FINAL FINDINGS AND DECISION BY THE DESIGN COMMISSION RENDERED ON March 5, 2015

CASE FILE NUMBER: LU 14-225506 DZM AD PC # 14-199508 AC HOTEL by MARRIOTT

Design review for a new 204 room hotel on a vacant 10,000 square foot lot – 13 floors plus one below grade level on existing vacant lot. The gross building floor area will be approximately 118,000 square feet and building height will be approximately 130'. Ground floor program includes a bar, lounge, lobby, dinning, long-term bike storage (11 space per code requirement) and back of house. No on-site parking is proposed. Parking demand will be satisfied within a

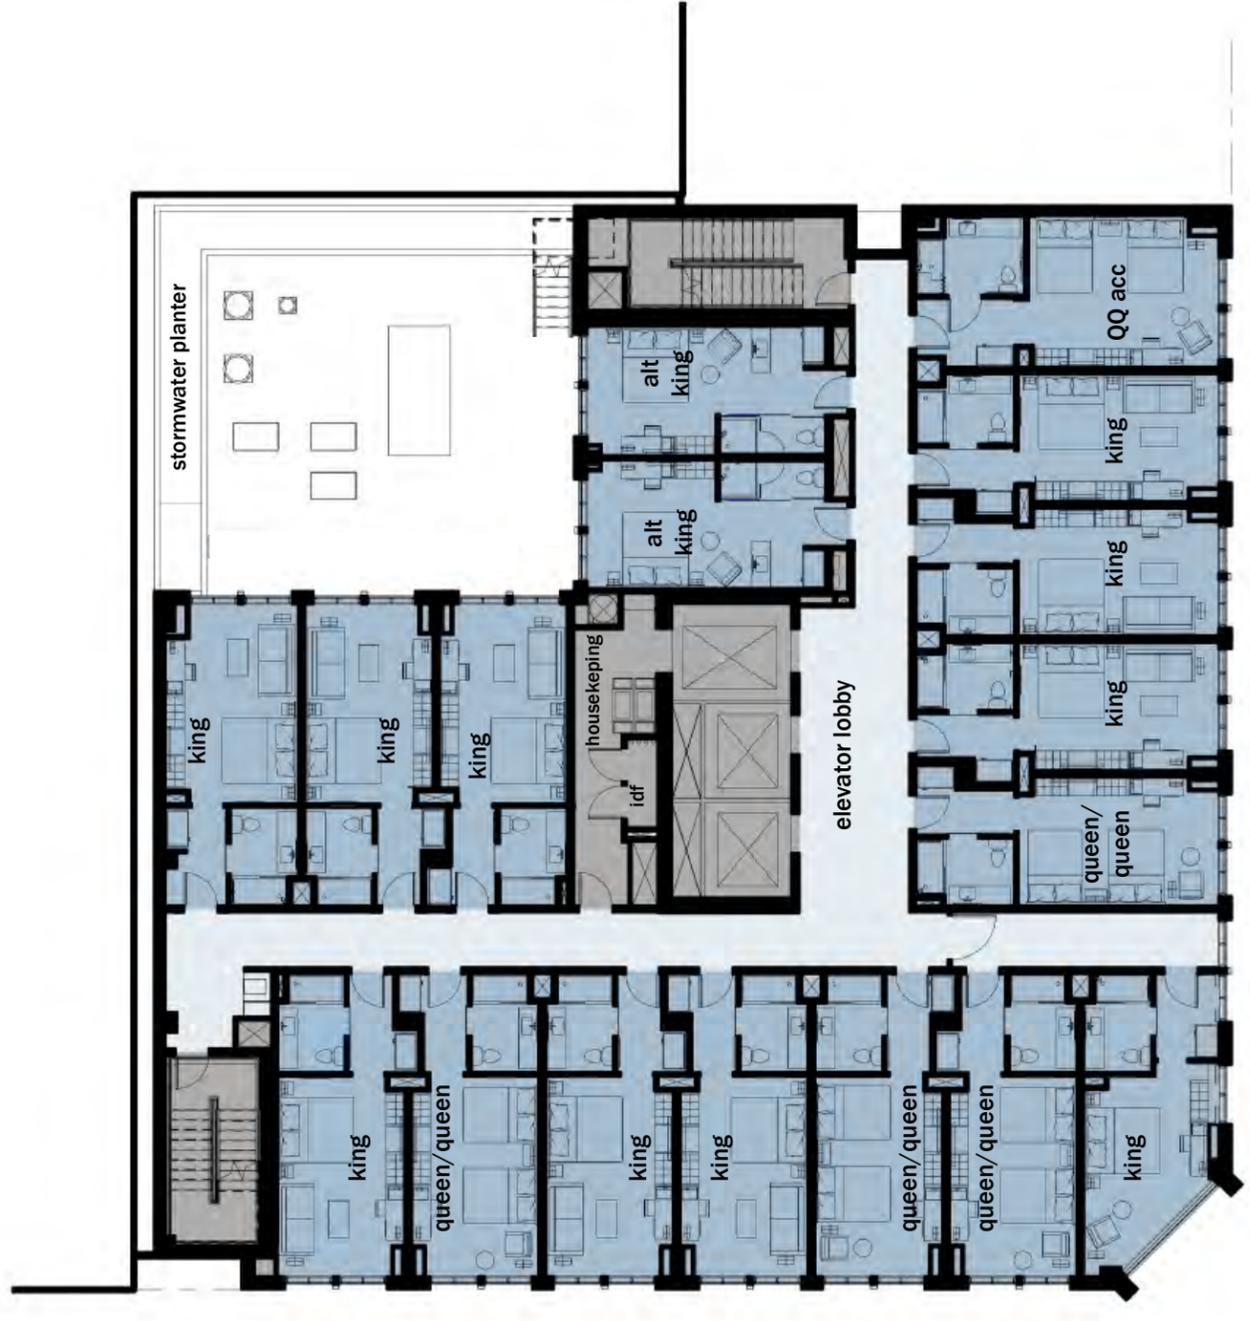
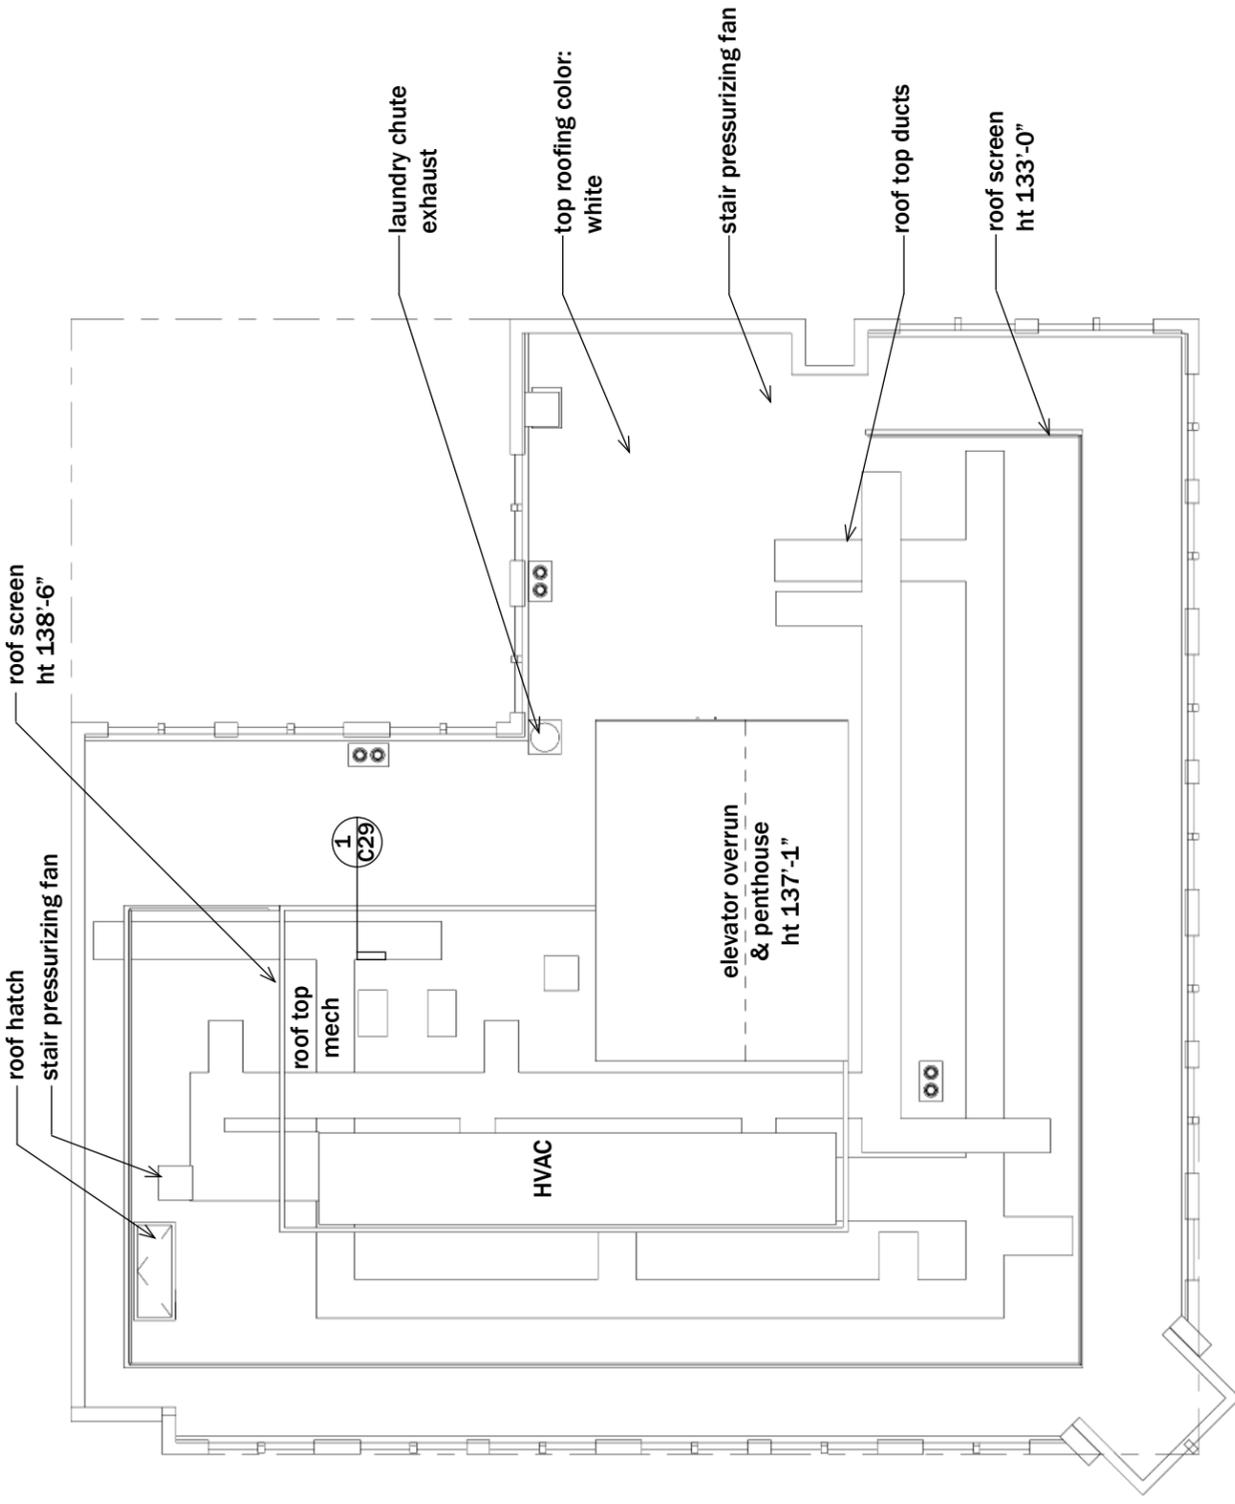
At the hearing, Design Commissioners determined that the corrugated metal canopy roofs at the ground floor was neither a contextually derived nor an appropriately permanent material and was therefore inappropriate for application in this project. The Commission concluded that glass would better promote coherency, quality and permanence. *Therefore, with the Condition of Approval requiring that all canopy roofs be glass, these guidelines are met.*

- A.** As part of the building permit application submittal, the following development-related conditions (A – D) must be noted on each of the 4 required site plans or included as a sheet in the numbered set of plans. The sheet on which this information appears must be labeled “ZONING COMPLIANCE PAGE- Case File LU 14-225506 DZM AD. All requirements must be graphically represented on the site plan, landscape, or other required plan and must be labeled “REQUIRED.”
- B.** All exterior brick cladding shall be specified as Mutual Materials Face Brick color Granite or a similar color value range (equivalency of tan to beige).
- C.** The roof material on all ground floor canopies shall be glass.
- D.** No field changes allowed.

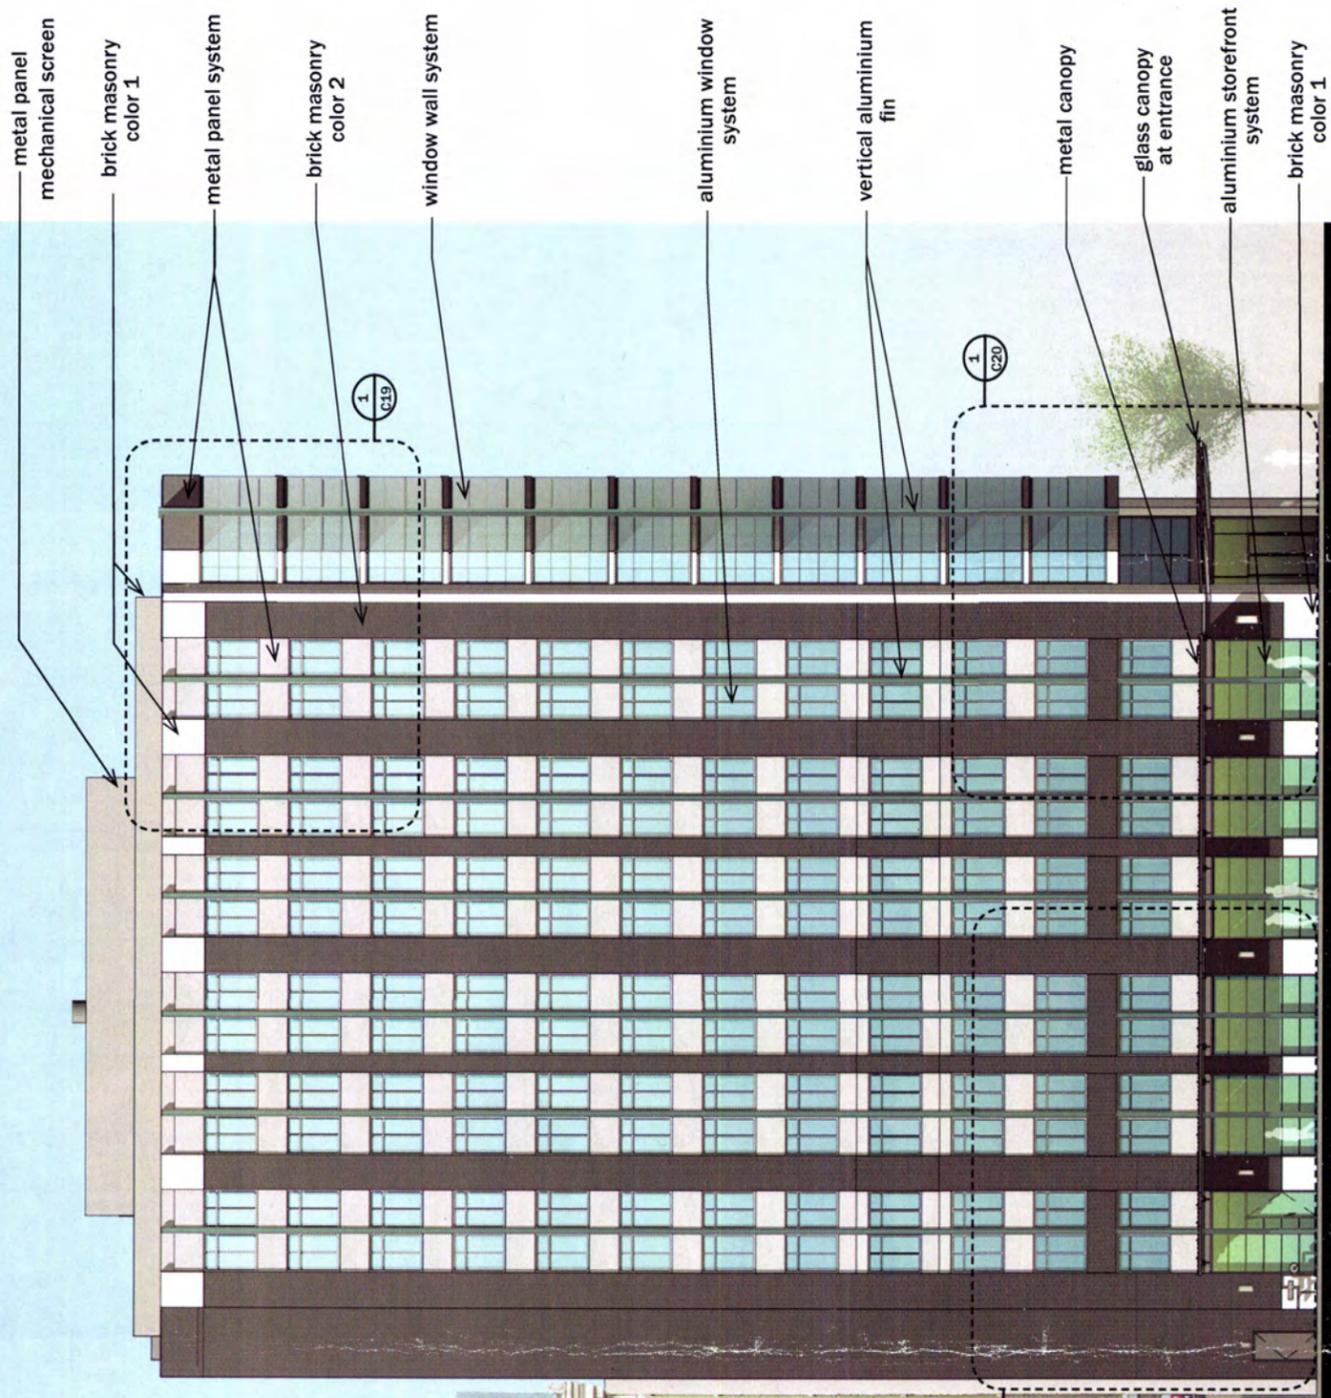
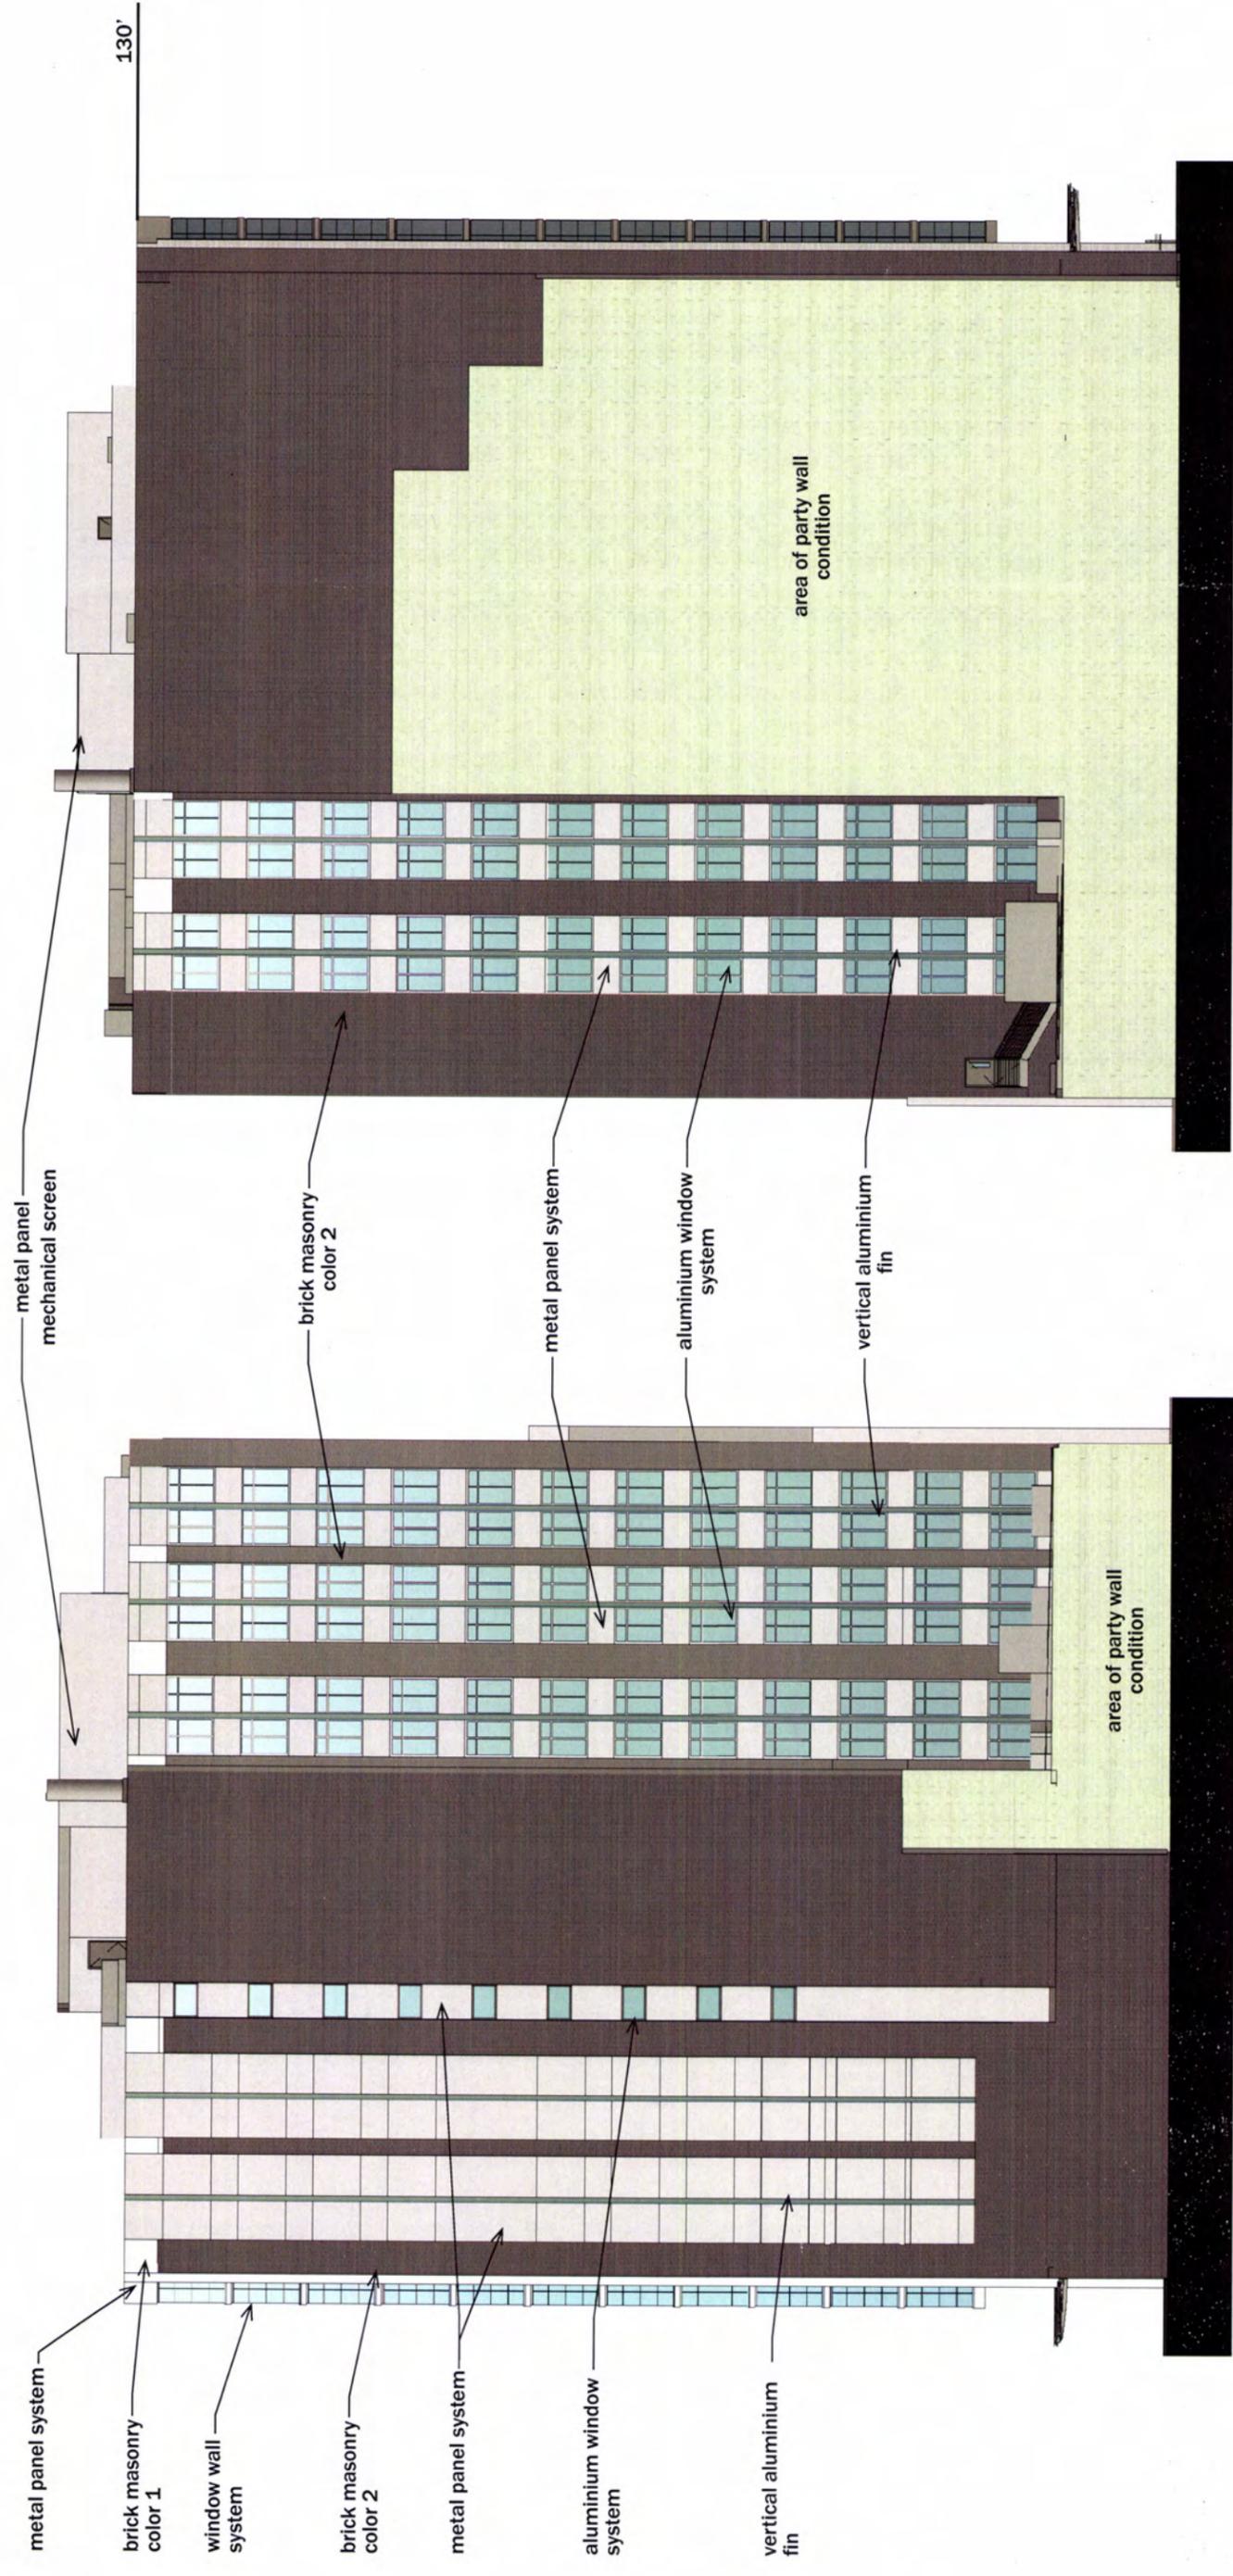
At the hearing Design Commissions observed that the dark brick color was too great a contrast with lighter colored brick buildings in the project vicinity. They determined that a singular tan brick color would better reinforce the coherency of the district. *Therefore, with the Condition of Approval requiring a beige or tan brick color these guidelines are met.*
